CONSTRUCTION PLANS
FOR
**CARRIAGE MEADOW SOUTH AT
LORSON RANCH FILING NO. 2**
STREET/STORM SEWER AND UTILITY CONSTRUCTION PLANS

CORE ENGINEERING GROUP	DATE: _____
	DESCRIPTION: _____
NO. _____	PROJECT: CARRIAGE MEADOWS SOUTH AT LORSON RANCH FILING NO. 2
DRAWN: RLS	PREPARED FOR: LORSON, LLC
DESIGNED: RLS	212 N. WAHSATCH AVE. SUITE 301
CHECKED: RLS	COLORADO SPRINGS, COLORADO 80903
COVER SHEET STREET/STORM SEWER AND UTILITY PLANS	
DATE: DECEMBER, 2018	
PROJECT NO. 100.046	
SHEET NUMBER C0.1	
TOTAL SHEETS: 21

DATE: DECEMBER, 2018
 PROJECT NO. 100.046
 SHEET NUMBER C6.1
 TOTAL SHEETS: 21

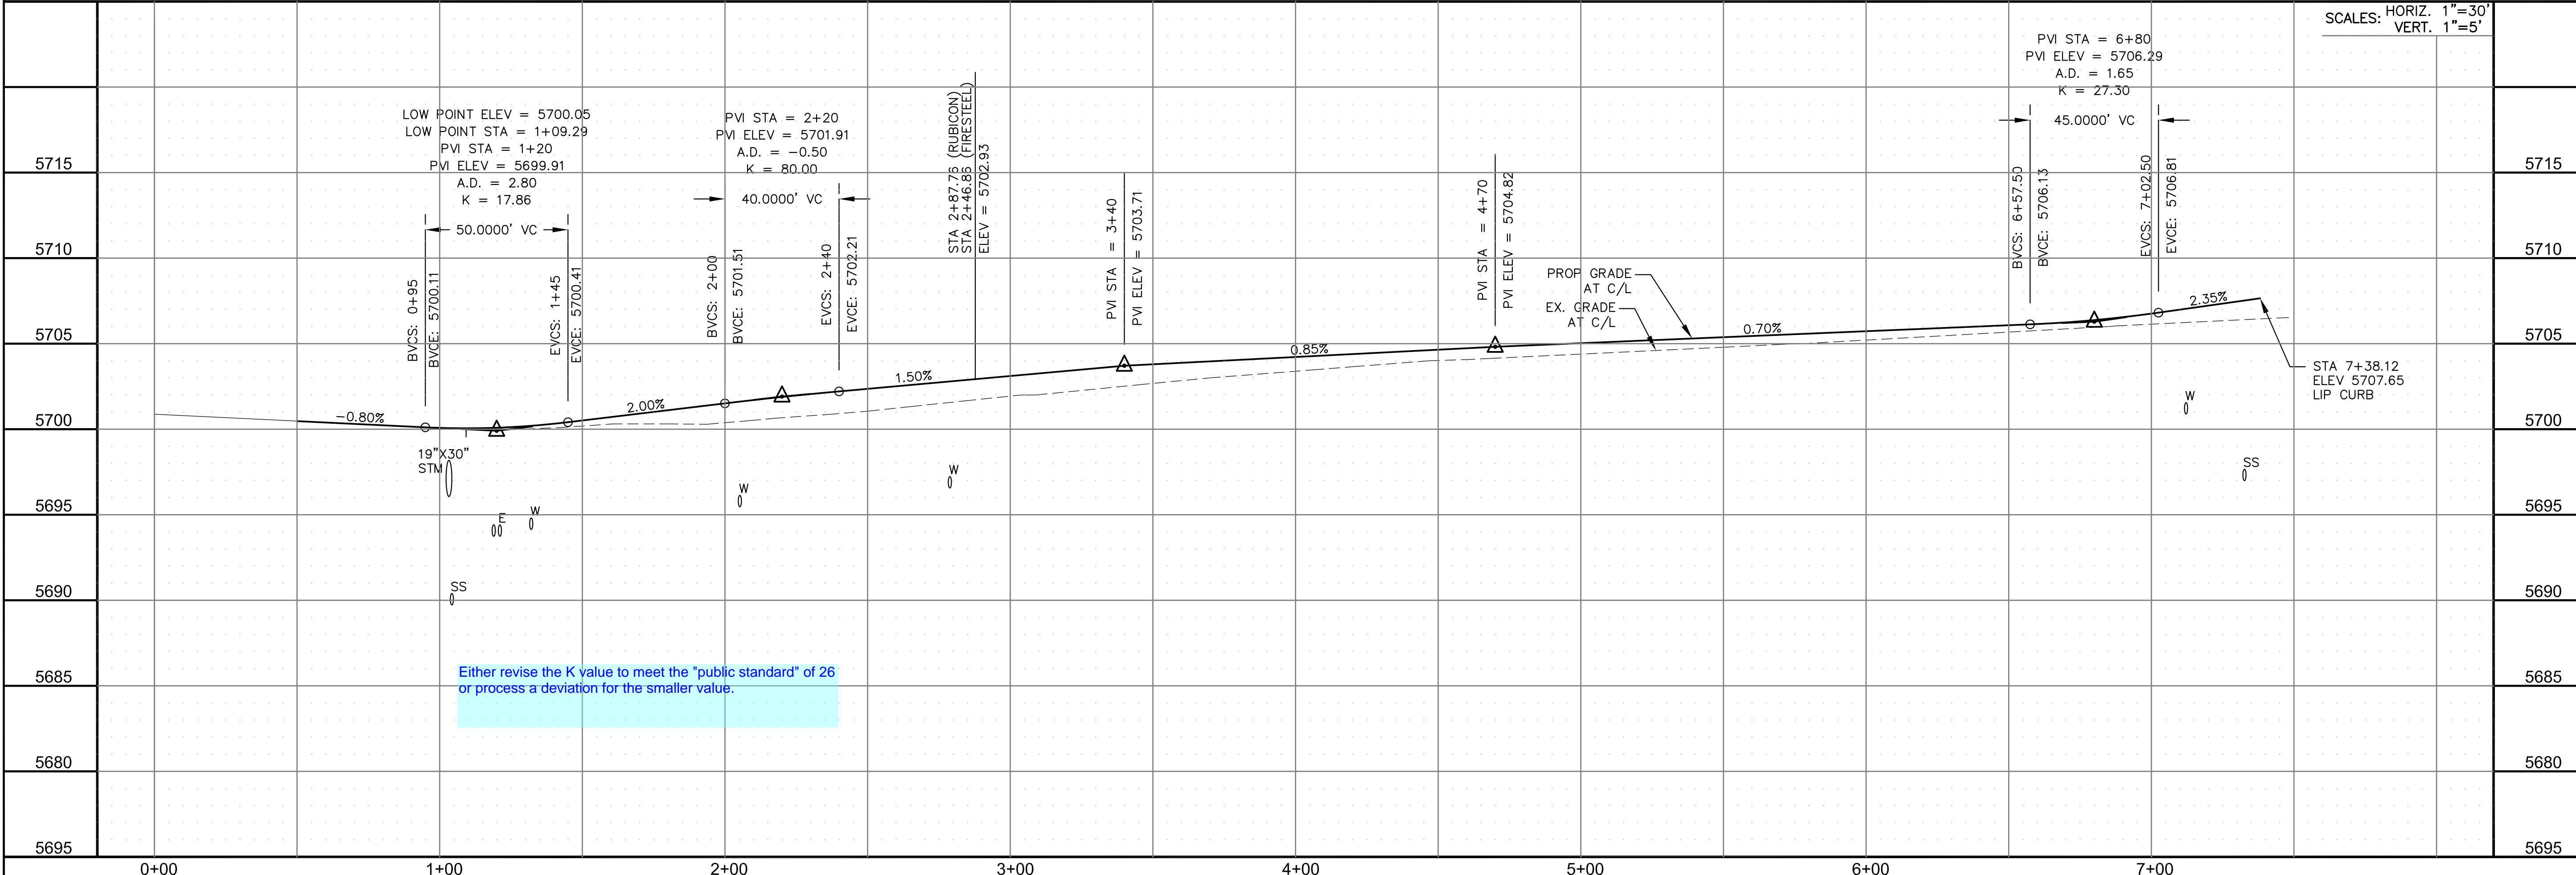
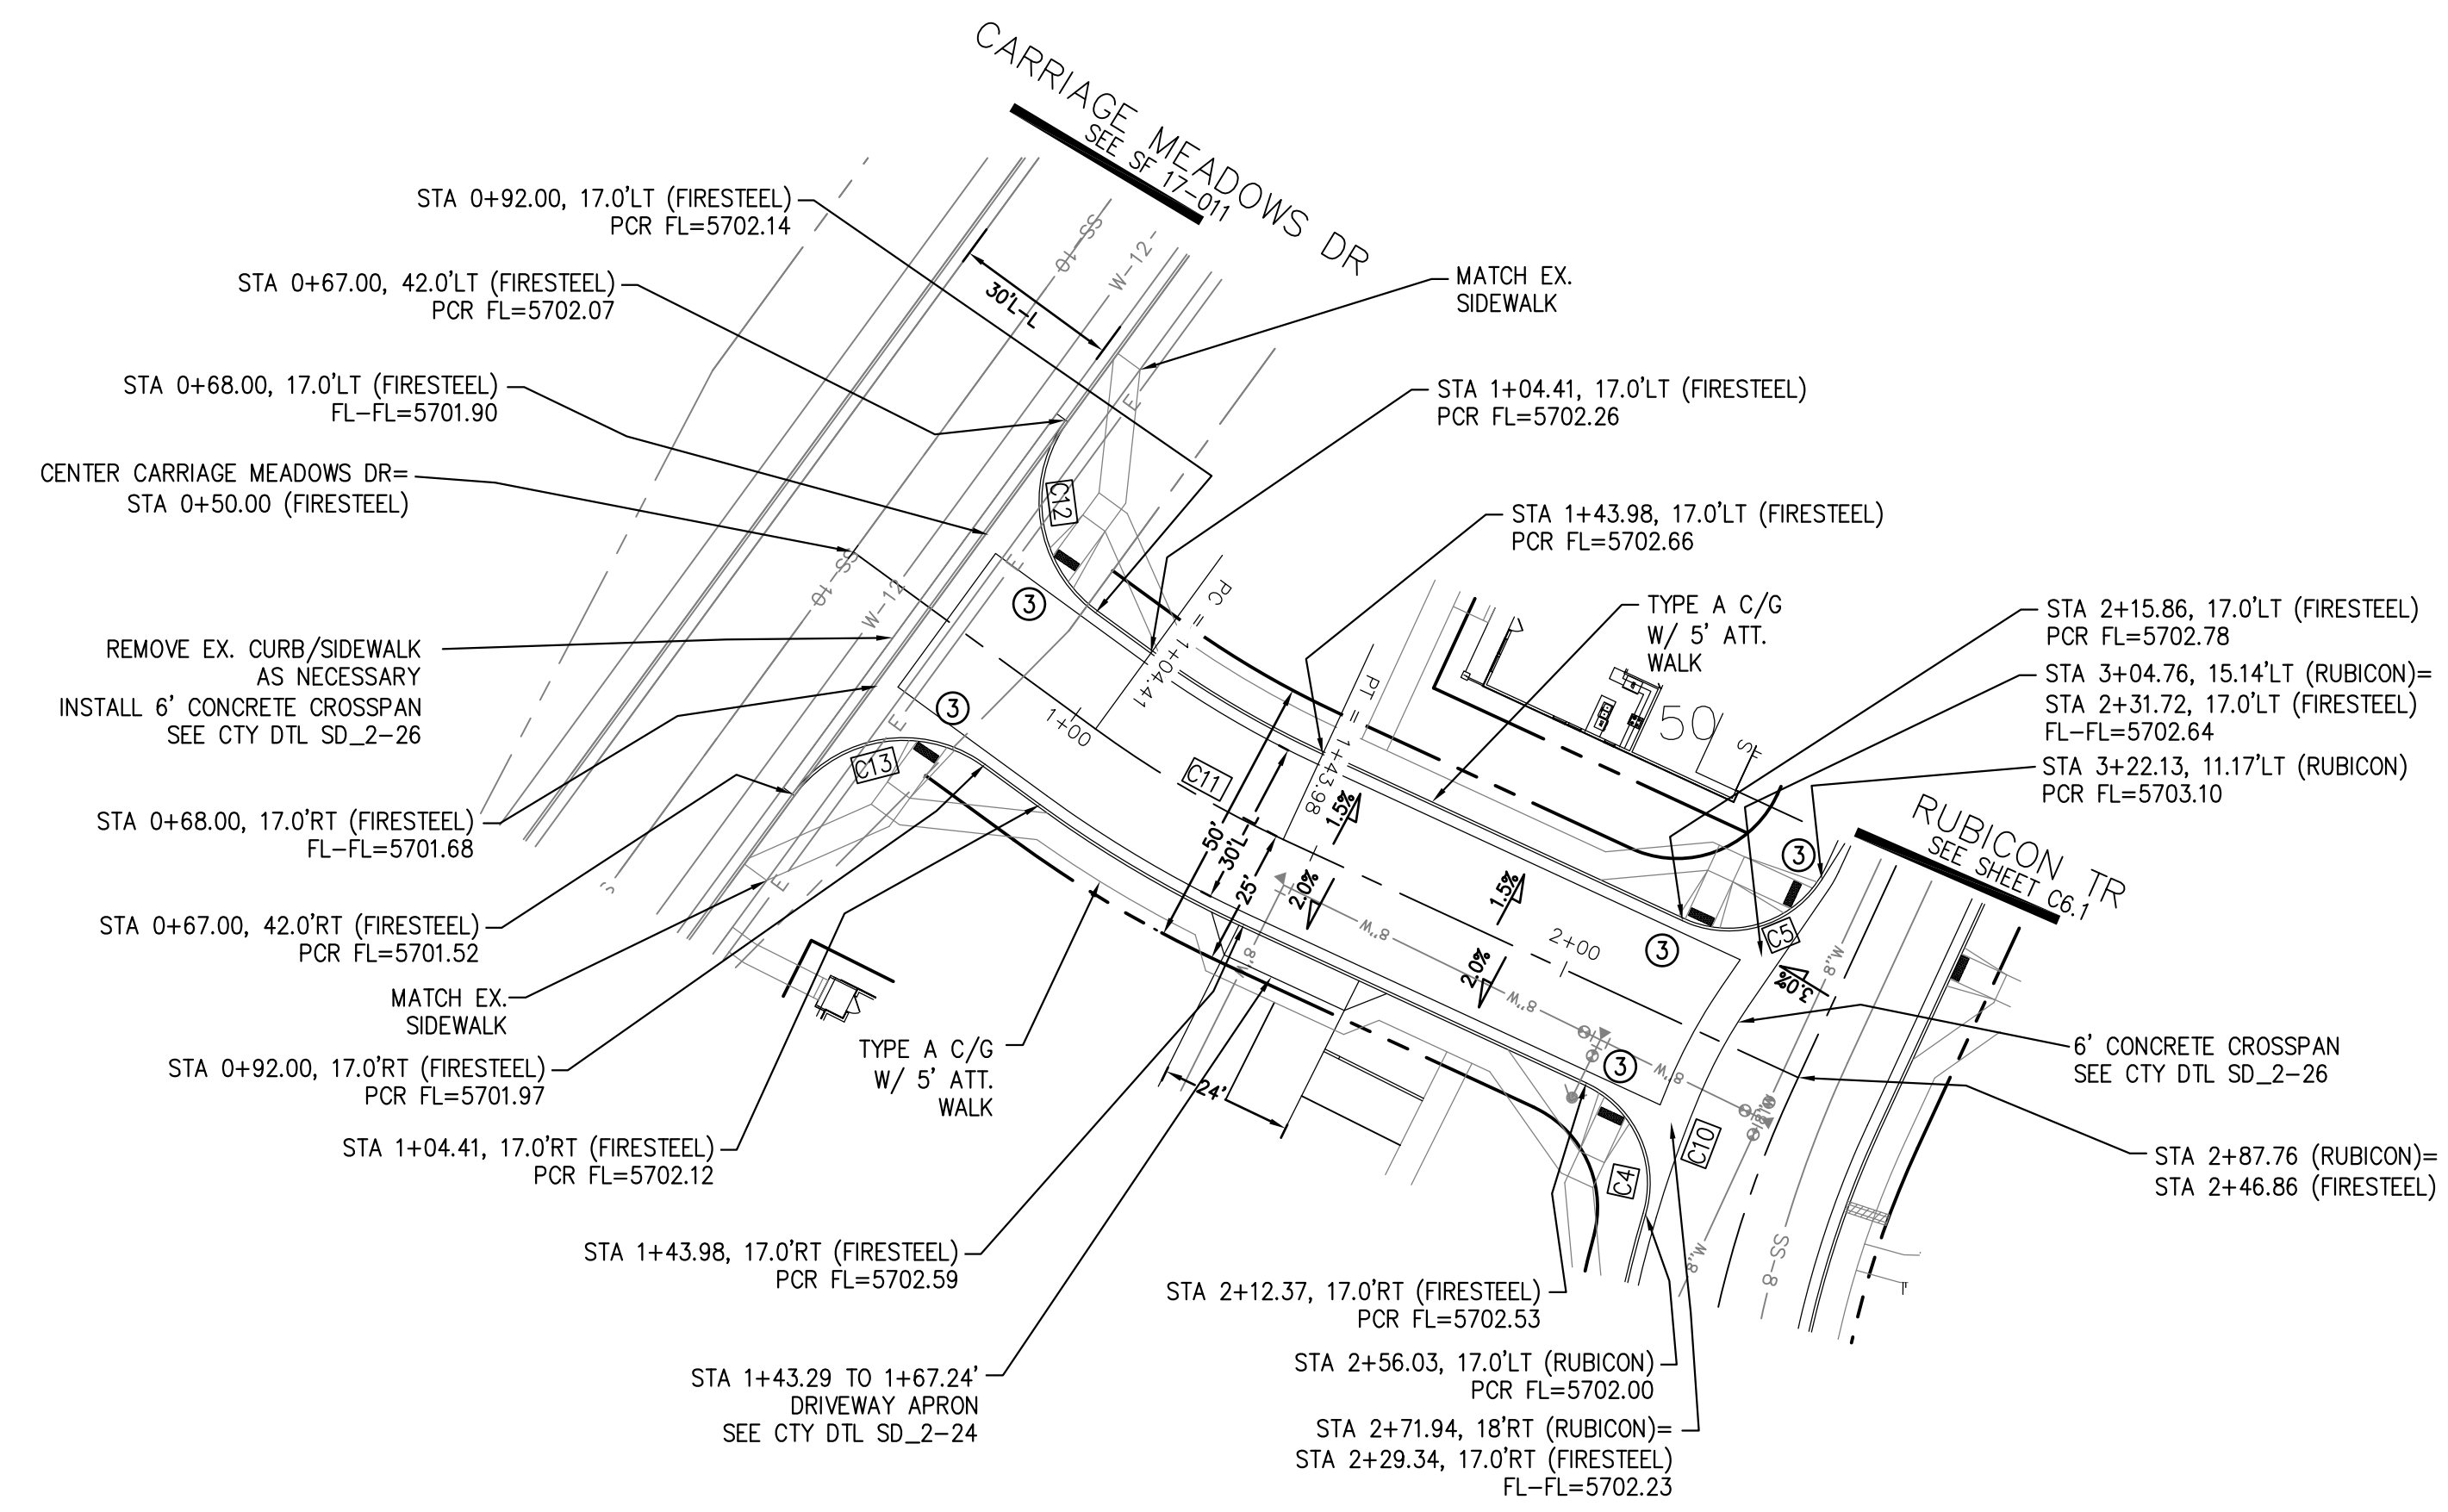
Either revise the K value to meet the "public standard" of 26 or process a deviation for the smaller value.

DATE: DECEMBER, 2018
PROJECT NO.: 100.046
SHEET NUMBER: C10.2
TOTAL SHEETS: 21

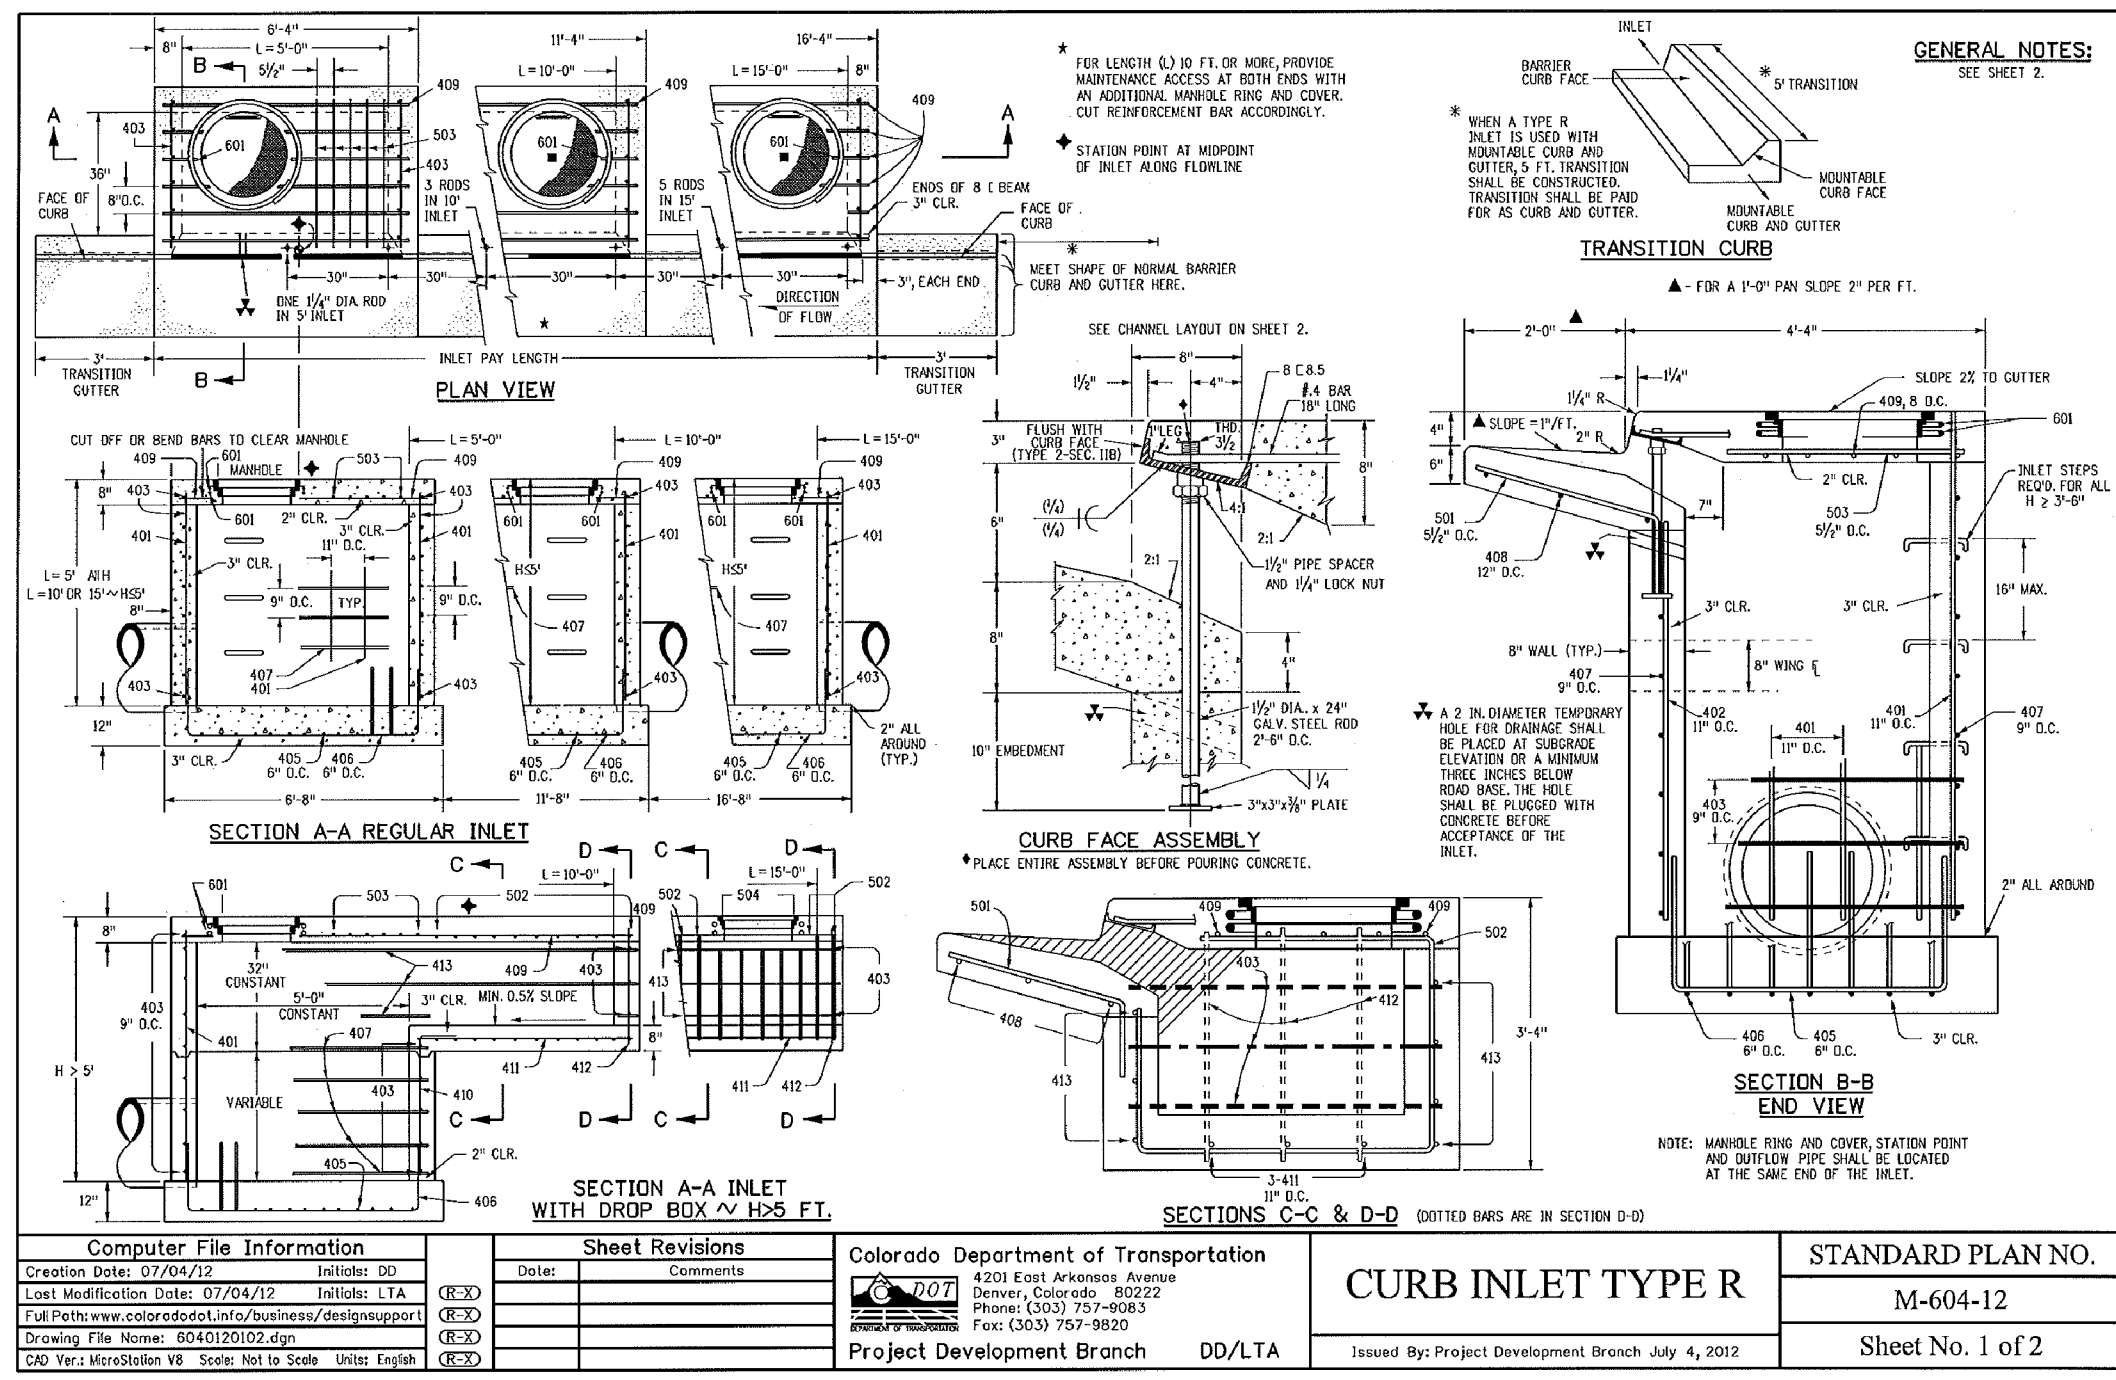
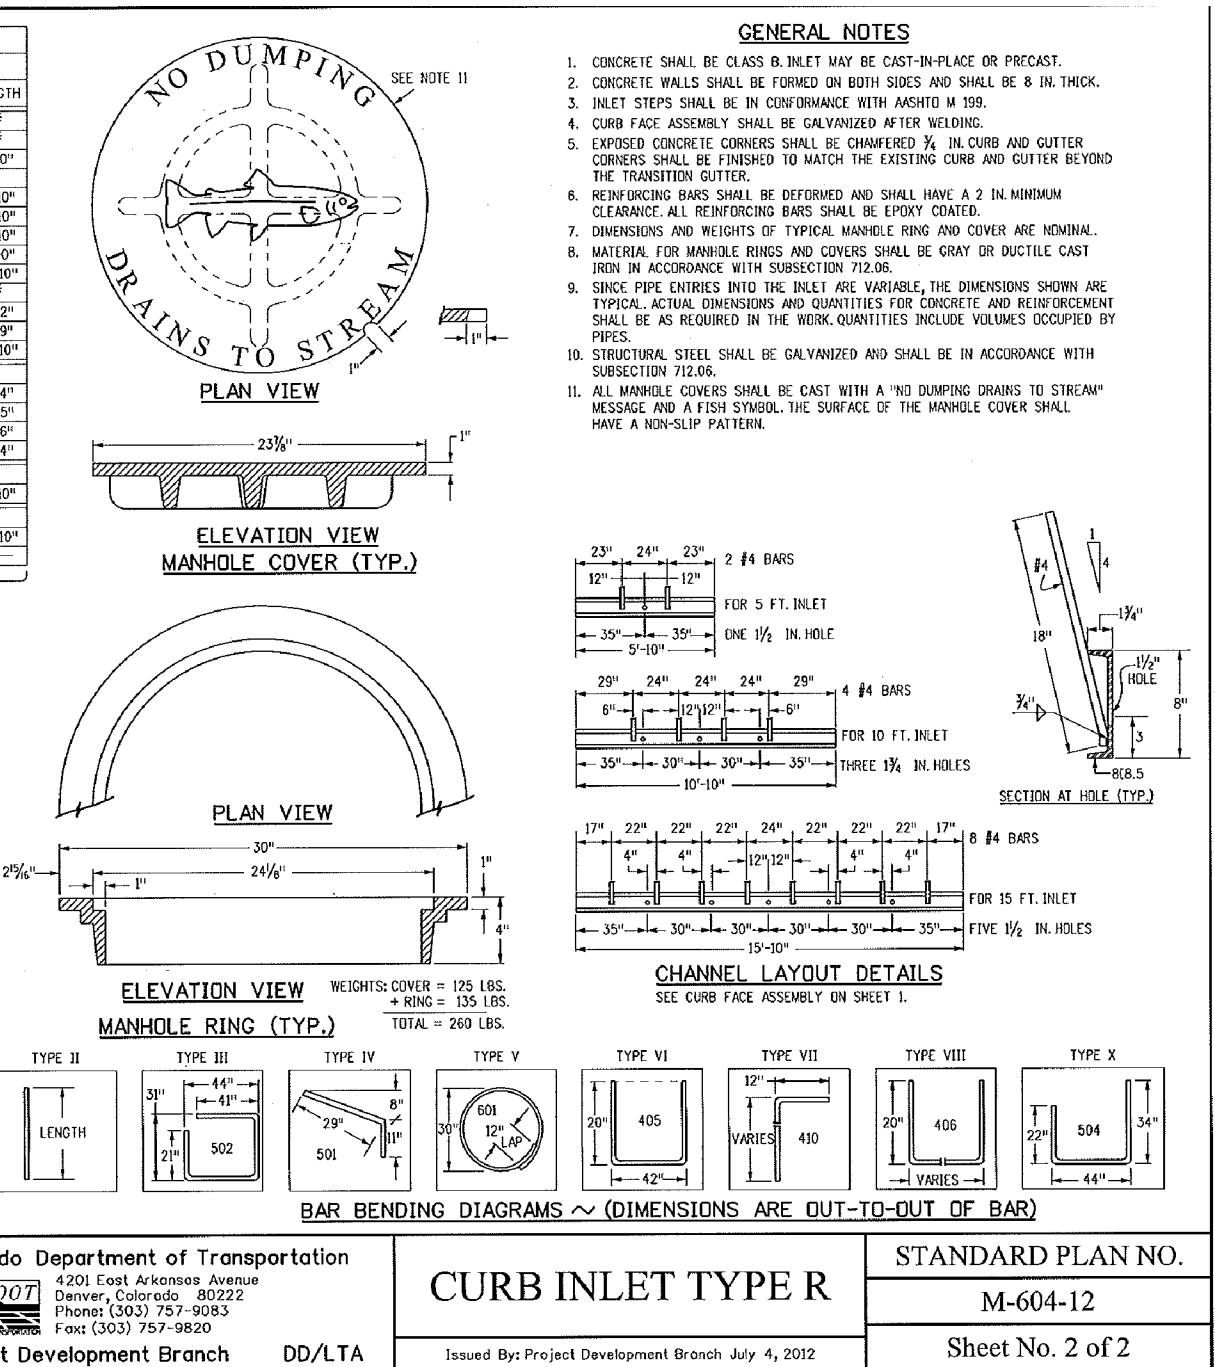
Please expand the size of these 10 details so they cover evenly these two plan sheets. We would like to be able to have the printed out and read on an 11 X 17 paper.
